RESPONSE TO COMMENTS NPDES PERMIT NO. MAG590000 MEDIUM WASTEWATER TREATMENT FACILITY GENERAL PERMIT

In accordance with the provisions of 40 Code of Federal Regulations (CFR) §124.17, this document presents EPA's responses to comments received on the Draft NPDES General Permit # MAG590000 ("Draft General Permit"). The Response to Comments explains and supports EPA's determinations that form the basis of the Final General Permit. From February 8, 2022, through April 26, 2022, EPA solicited public comments on the Draft General Permit.

Annual Minimum 7-day Average Flow Normalized by Drainage Area for Three Gages near Northbridge

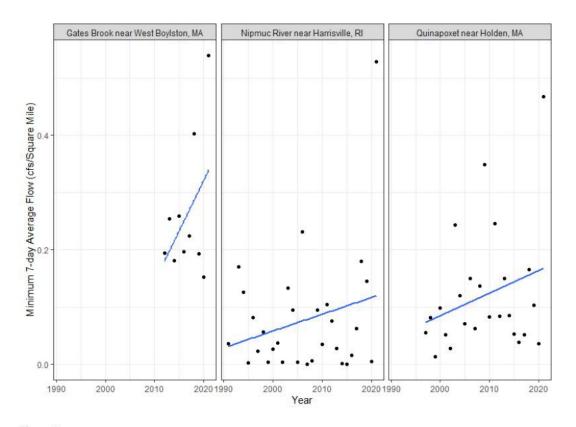
For each gage, the minimum 7-day average flow was calculated between 1991 and 2021 for each year and plotted to evaluate whether regional hydrologic changes would support such a significant reduction in the 7Q10 flow³. This analysis (**Figure 1**) indicates that the 7-day average low flow exhibits an upward trend at all four gages. This assessment therefore indicates that regional baseflow has not been trending down since the previous permit was issued in 2012, and does not support the nearly two orders of magnitude reduction in 7Q10 flow indicated by EPA's revised analysis in this Draft General Permit.

Figure 2
7Q10 Analysis for USGS 01095434 Gates Brook near West Boylston MA

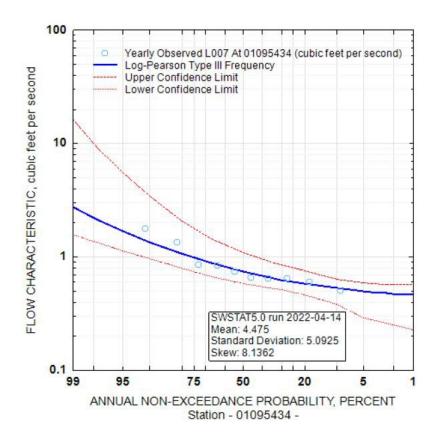
- Using standard calculation techniques with a Log-Pearson Type III fit to the streamflow data (using USGS SW Toolbox version 1.0.5)
- Using the regression equations in StreamStats. The calculated 7Q10 for this gage is 0.525 cfs, with a 95% confidence interval of 0.379 0.631 cfs (**Figure 2** and **Attachment 2**).

Based on the USGS-reported drainage area for the Gates Brook gage (3.13 mi2), the 7Q10 flow is 0.168 cfs/mi2 with a 95% CI of 0.121 – 0.202 cfs/mi2. Scaled to the drainage area of the unnamed tributary (1.45 mi2) the Northbridge discharge would represent a 7Q10 flow between 0.18 and 0.29 cfs – lower than the current 7Q10 flow, but not a decrease of an order of magnitude that is proposed in the Draft General Permit. Furthermore, for Gates Brook, the calculated 7Q10 and estimated 7Q10 using StreamStats vary by an order of magnitude here, as well, suggesting that the StreamStats estimate is not a reliable calculation for the 7Q10 flow for small streams in this region.
